**ADDENDUM TO TECHNICAL DRAINAGE STUDY
FOR
*Kyle Canyon Road and Oso Blanca Road***

**JOB NO. 200203
AUGUST 2022**

COMMENT LETTER

C10

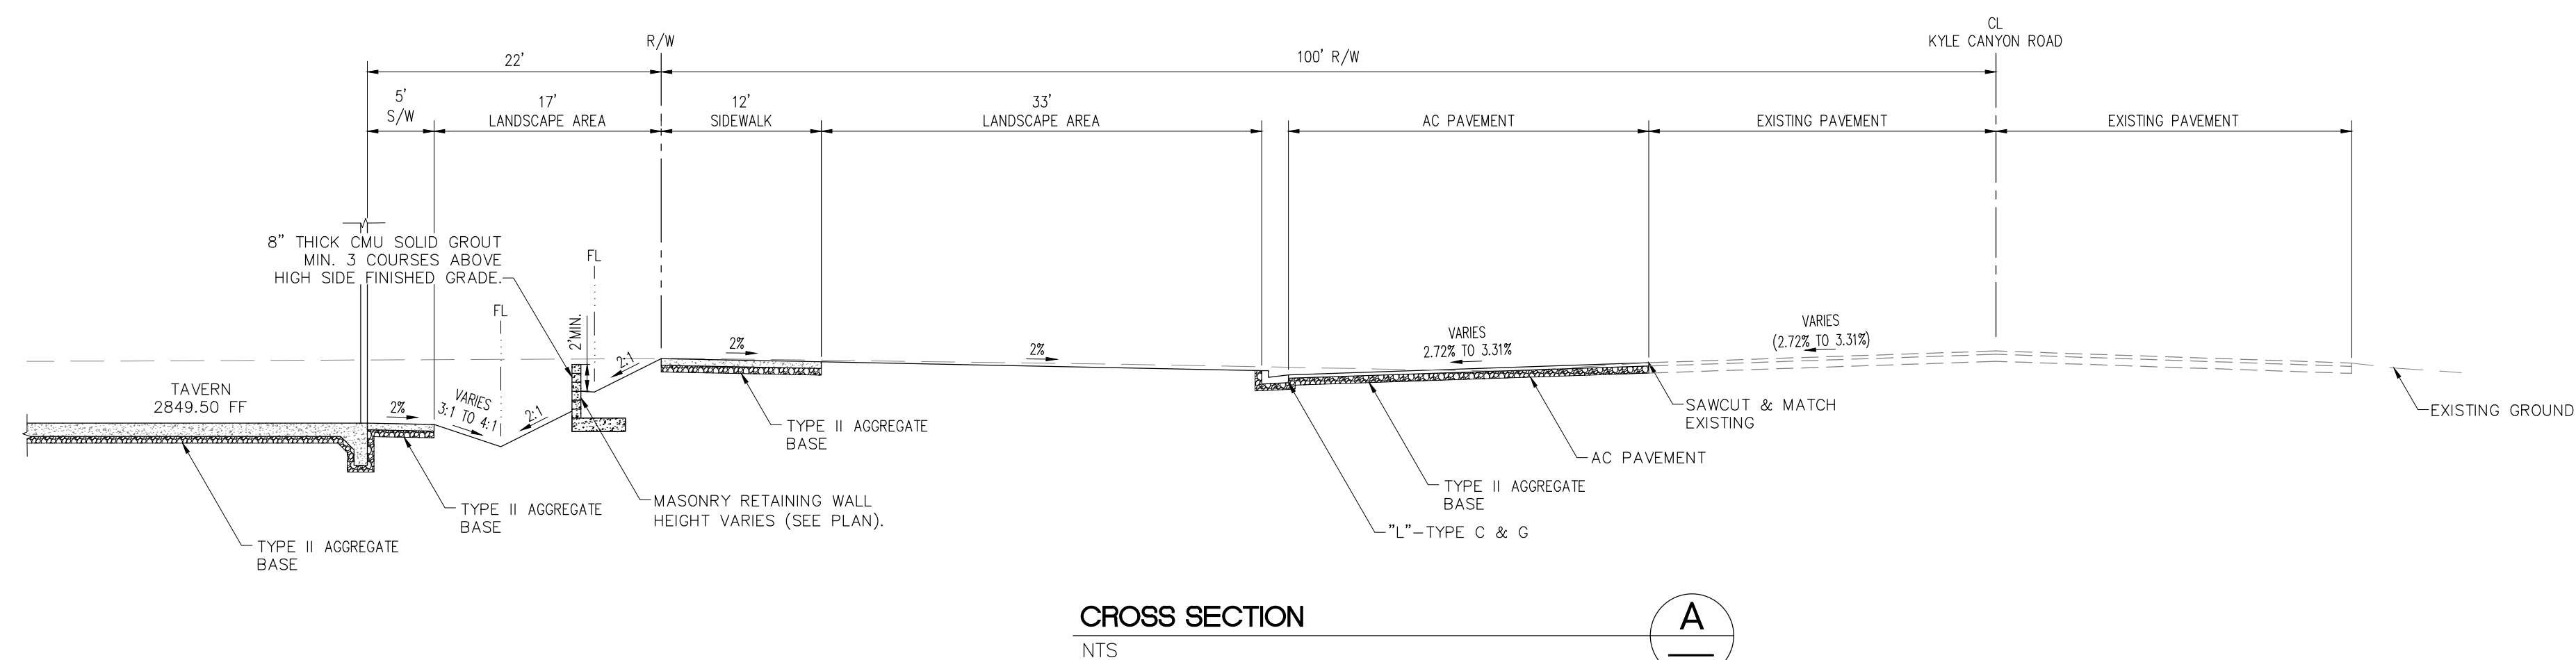
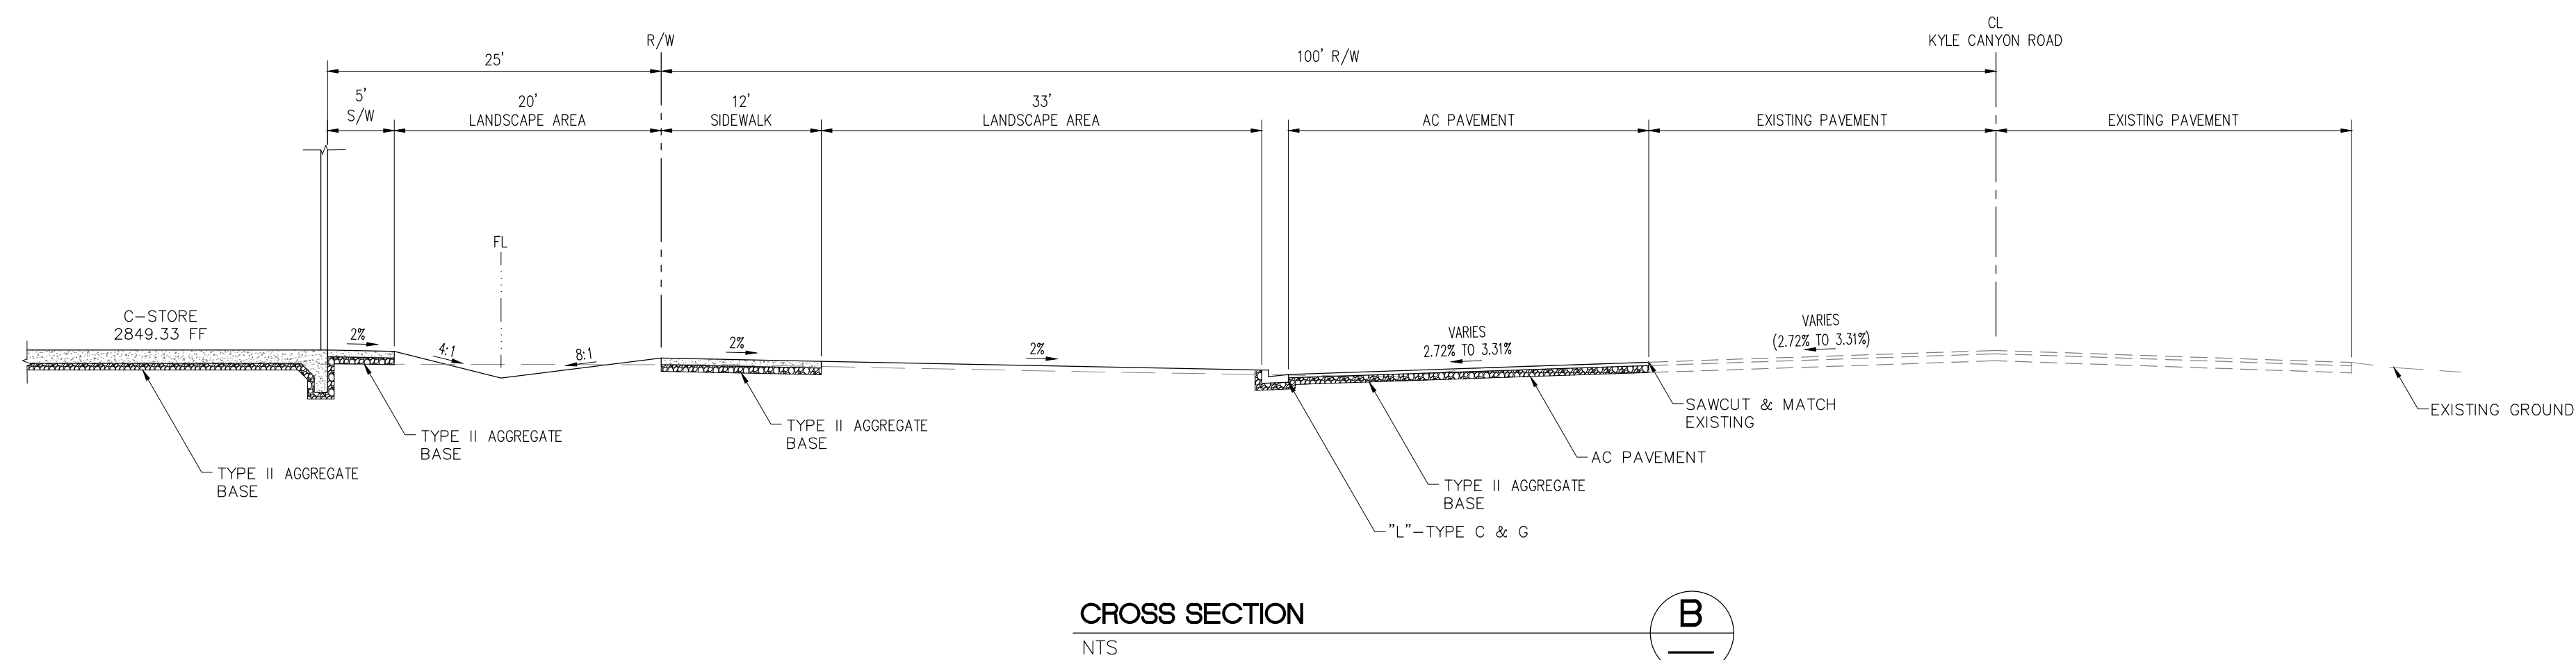
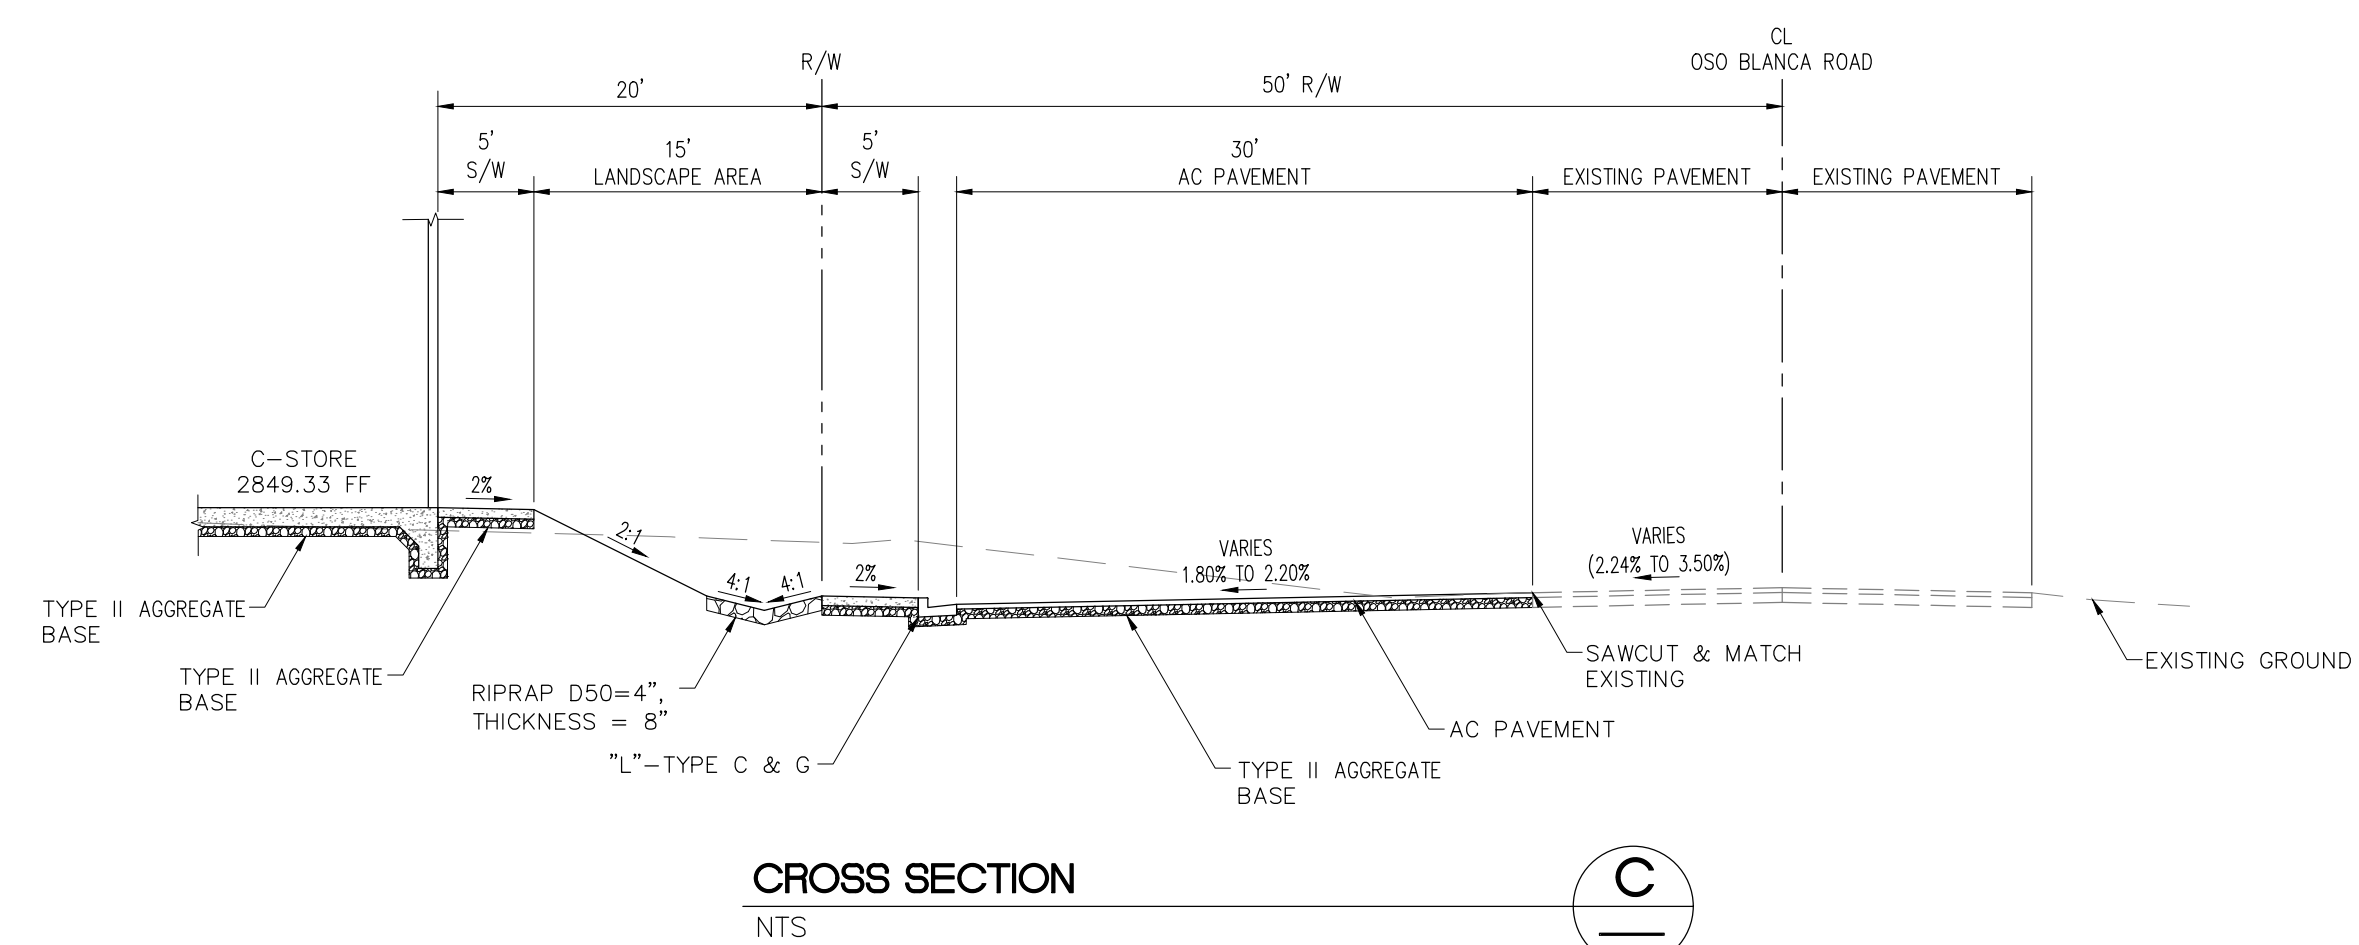
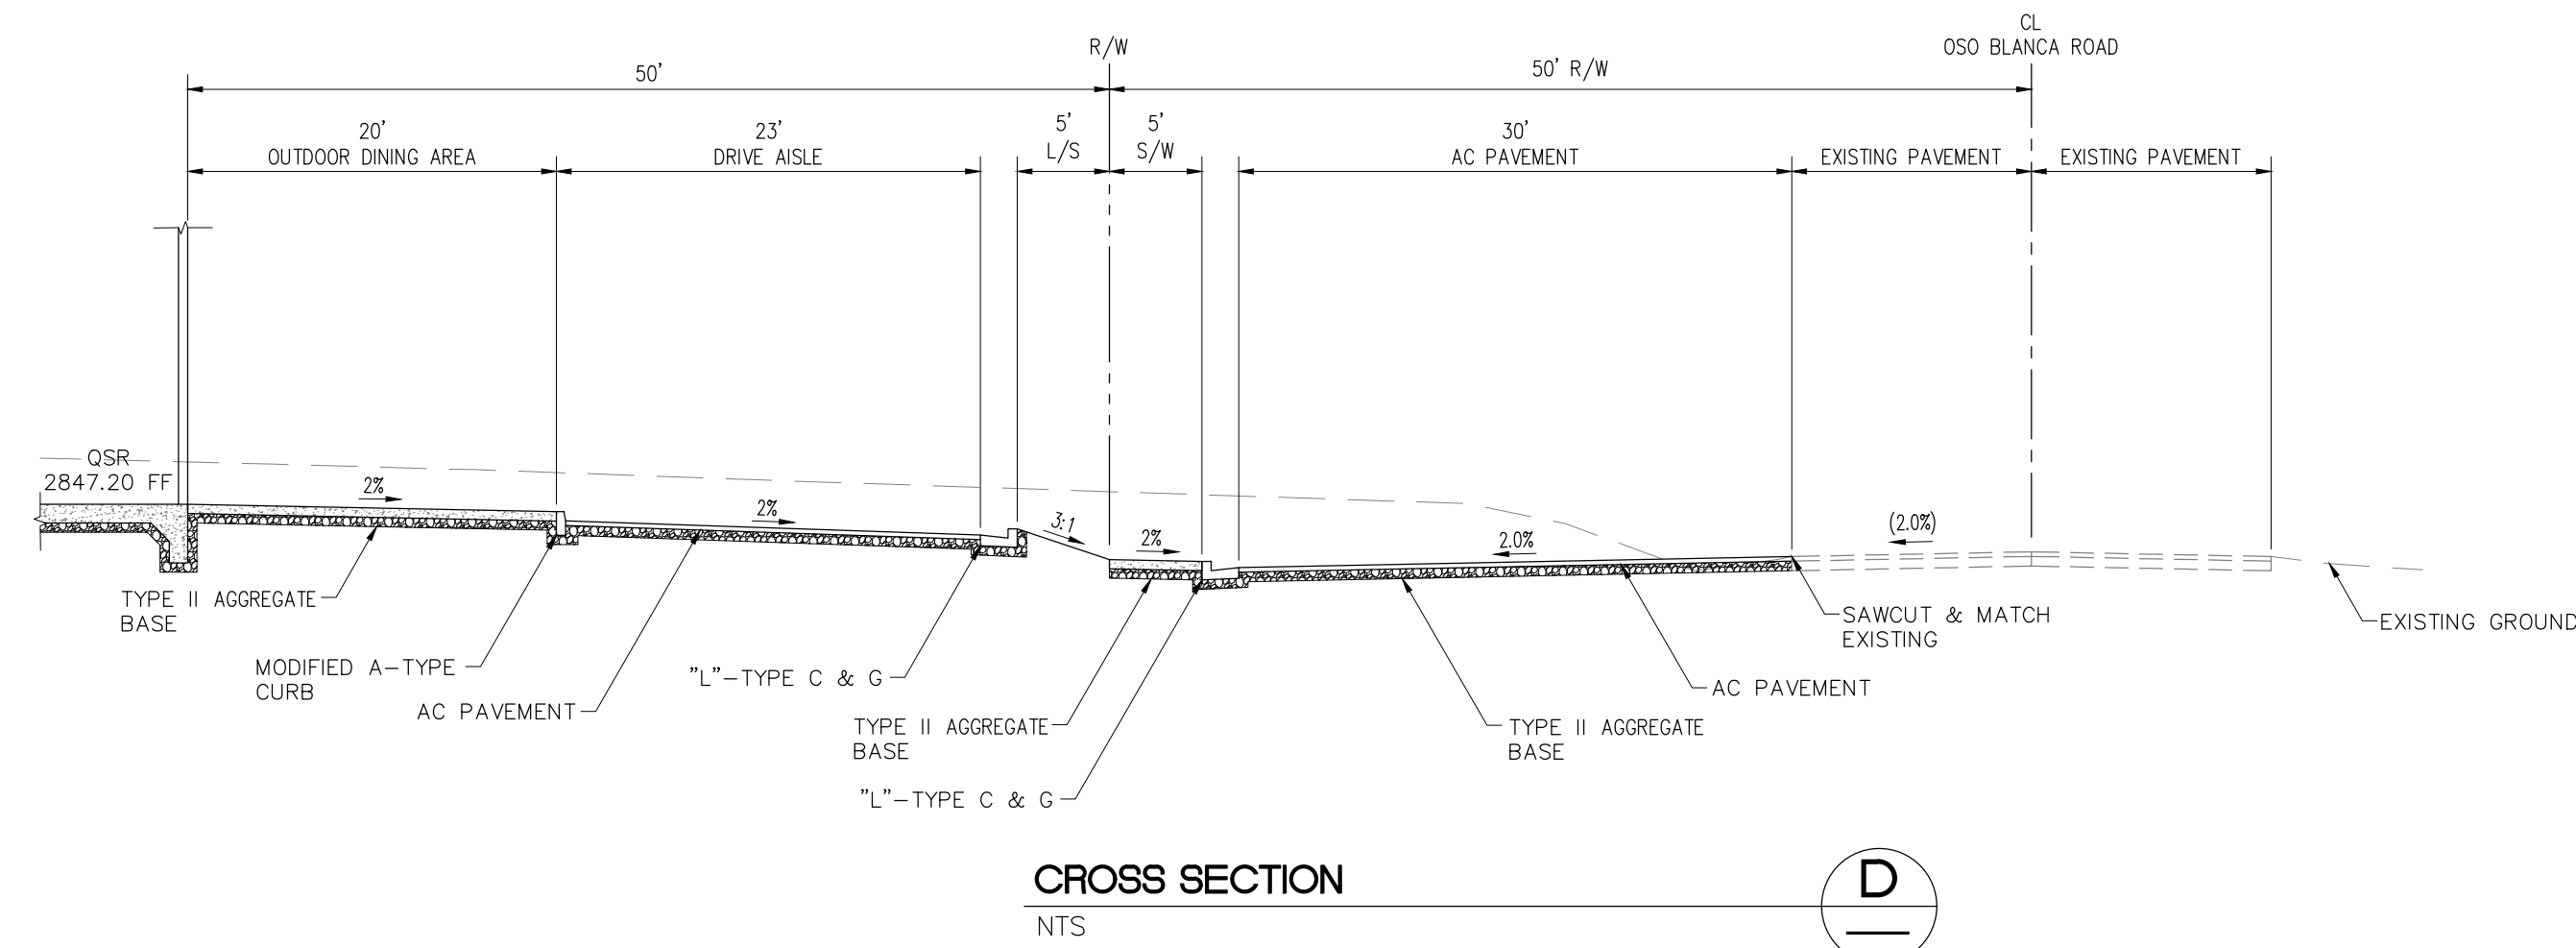
- 15) **Sheet C10: Section Detail A:** Clearly show that the top three courses of the retaining wall to be 8"-thickness CMU to be solid grouted or equivalent above the adjacent high grade.

Response 15: Noted.
